工程指示 / 要求簡箋(E.I.)

工程指示編號：EI / 3002 / 21

工程名稱：亞皆老街中電

工程項目：露台鋁板 C 單位 地盤用鋁板 (T1-T3) (3-6/F)

名稱	鋁板加工圖	制圖	LHR	2020.12.27	修改	D	B	C
材料	3mm THK. ALUM. CLADDING	復核	-	-	日期	2021.04.22	2021.02.24	2021.03.19
顏色	UCT201498XL(A)-3	批准			圖號	J852-ACA-ACB-C03

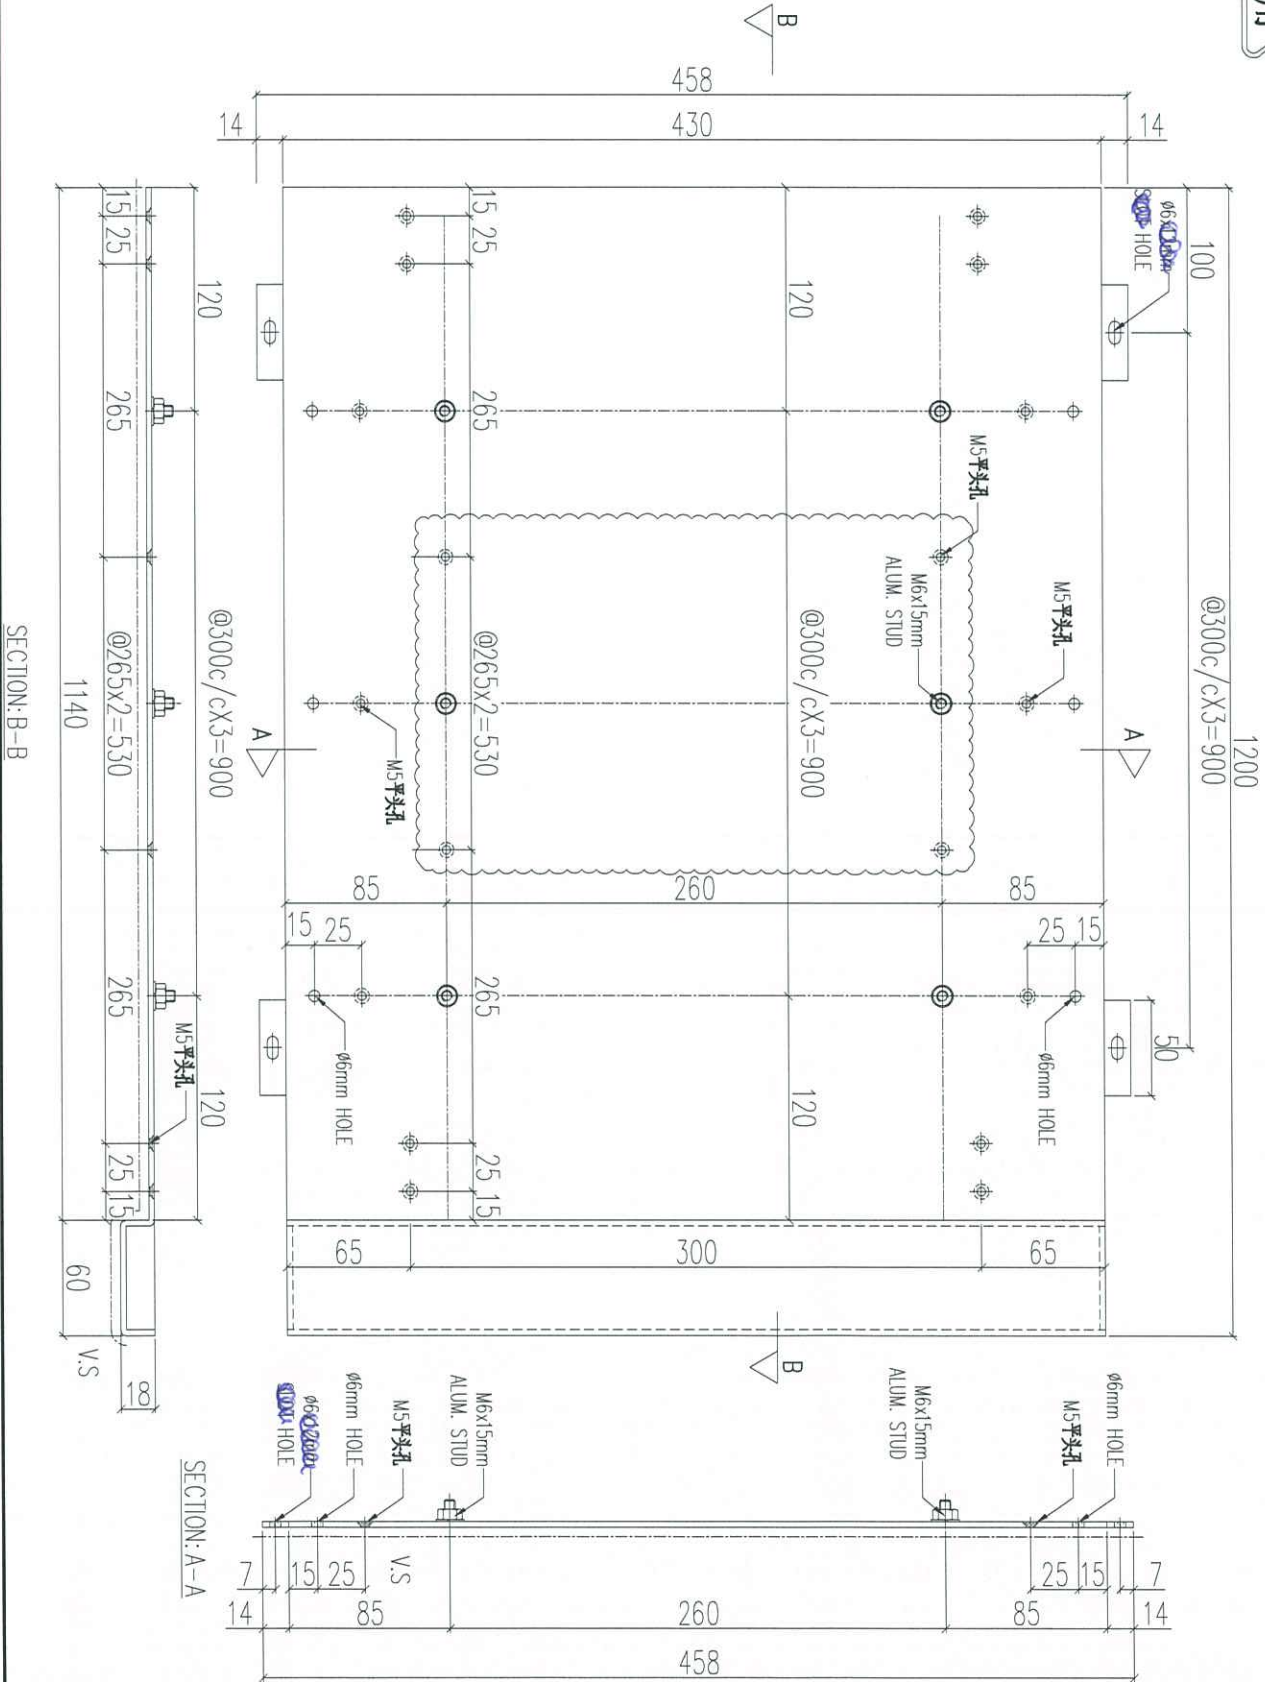
G 版: 已修改 ACB-C01/ C02/ C03/ C04/ C05. 所有長孔改梗孔, 顧問只接受梗孔.
